HEARING STREAM 12: REZONING REQUESTS (LARGER SCALE)

STATEMENT OF EVIDENCE OF ANTONI FACEY

ANDREW CARR (SUBMITTER #158)

Request for Rezoning 308 Cones Road / 90 Dixons Road

Figure 6: Proposed Outline Development Plan

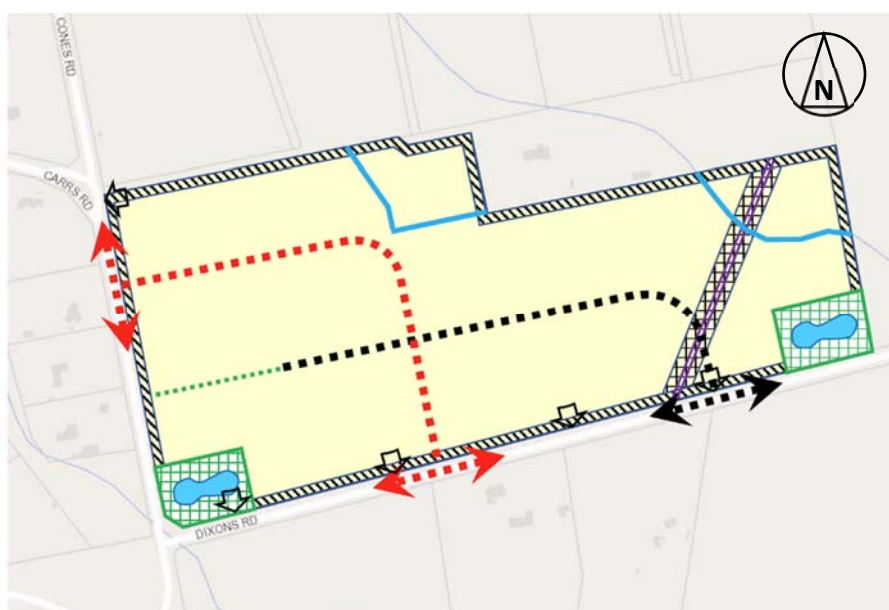
Council Comment: The ODP includes intersections at 270m apart, while the PDP anticipates a distance of 800m given the 100km/h speed limit;

- 5.2 I agree that the ODP shows intersections that are more closely spaced than the 800m set out in the PDP.
- 5.3 This matter was addressed in Section 8.2.4 of the Transportation Assessment, where it was noted that the separation of 800m was not supported by either the overarching national standard for land use (Standard NZS4404:2010 ('Land Development and Subdivision Infrastructure')) or the Austroads Guide. In brief it was stated that:

- a. Standard NZS4404:2010 suggests a separation of 150m;
 - b. The Austroads Guide suggests that 5 seconds of travel time is sufficient for a driver to see and assimilate the road ahead. In this case, this also equates to a distance of 150m;

- c. Even at a speed of 110km/h, a driver requires only 300m to see a vehicle ahead in a conflict situation, react and stop before a collision.
- 5.4 In my view these indicate that the provision of an 800m spacing is excessive. I have also not been able to find any document that provides support for this distance, whereas a separation distance of 150m to 300m does have support in recognised standards/guides.

- 5.5 From a practical perspective, the District Plan does not set out how separation distances are to be measured. However, I note that the Dixons Road / Cones Road intersection lies at the southwestern corner of the two sites (90 Dixons Road and 308 Cones Road). Along Cones Road, the sites have a combined frontage of less than 300m meaning that there is no location where the 800m separation could be achieved.

- 5.11 In my opinion, the better outcome from a road safety perspective is to have a smaller number of properly designed roading connections. While I am cognisant of the reduced separation compared to the PDP expectations, drawing on my own experience in road safety and the evaluation set out in the Transportation Assessment and summarised above, I remain of the view set out in my peer review that the reduced intersection separation is acceptable and can be supported. It is ample for drivers to see the roading network ahead of them, and to make appropriate driving choices.

6.2 Having reviewed the comments made by the council, I remain of the views expressed in my peer review. With specific regard to the separation of intersections, I confirm that I am able to support the reduced distances sought in this instance, and do not consider that it will give rise to adverse road safety effects. I also highlight that the alternative option to comply with the District Plan would be to form multiple private accesses, which I consider would not be an appropriate transportation solution.

Figure 1: Revised Weekday Morning and Evening Peak Hour Traffic Generation at Full Site Development

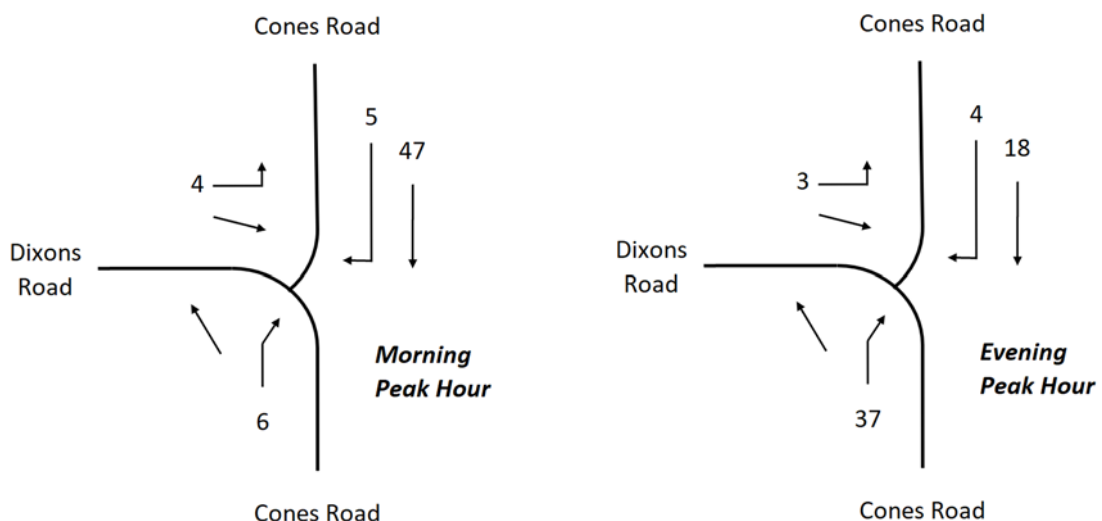
3.5 In my peer review, I identified that there would be merit in presenting a sensitivity test with a slightly higher traffic generation rate of 1.4 vehicle movements per lot in the peak hour. Mr Carr has provided a supplementary letter which addresses this, and this is attached as Annexure C.

- 4.3 I have reviewed Mr Carr's response to my recommendation of a sensitivity test with a slightly higher traffic generation rate of 1.4 vehicle movements

per lot in the peak hour. I agree that this continues to show that the busiest intersection will continue to operate with low levels of queuing and delays.

In summary there are few differences between the sensitivity test carried out previously, and the revised testing using the increased trip rate. The greatest change arises in the evening peak hour for the right-turn movement from Cones Road (north), but even this is a change of less than one second compared to the situation with no site development, and with no consequential change in queue length or level of service.
